MODEL 165 RX

BEVEL GEAR

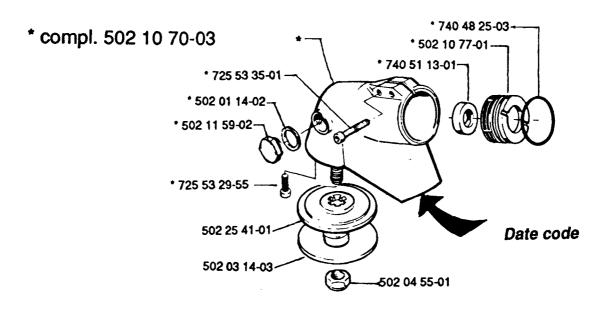
A new bevel gear with strengthened bearing housings and more reliable locking of the bevel gears has been introduced.

Damaged or worn gears should not be repaired (because of worn bearing housings). We recommend that the complete bevel gear is always replaced (also applies to earlier bevel gears ref. no. 502 10 70-01).

The new bevel gear is therefore only available as a complete unit, ref. no. 502 10 70-03. Manufacture of the new bevel gear began from date code 91-08. Introduced into production from serial no. 1090001.

NOTE! When changing sealing ref. no. 740 51 13-01 or O-ring ref. no. 740 48 25-01 the stop nut ref. no. 502 10 77-01 should be fixed with Loctite when fitted.
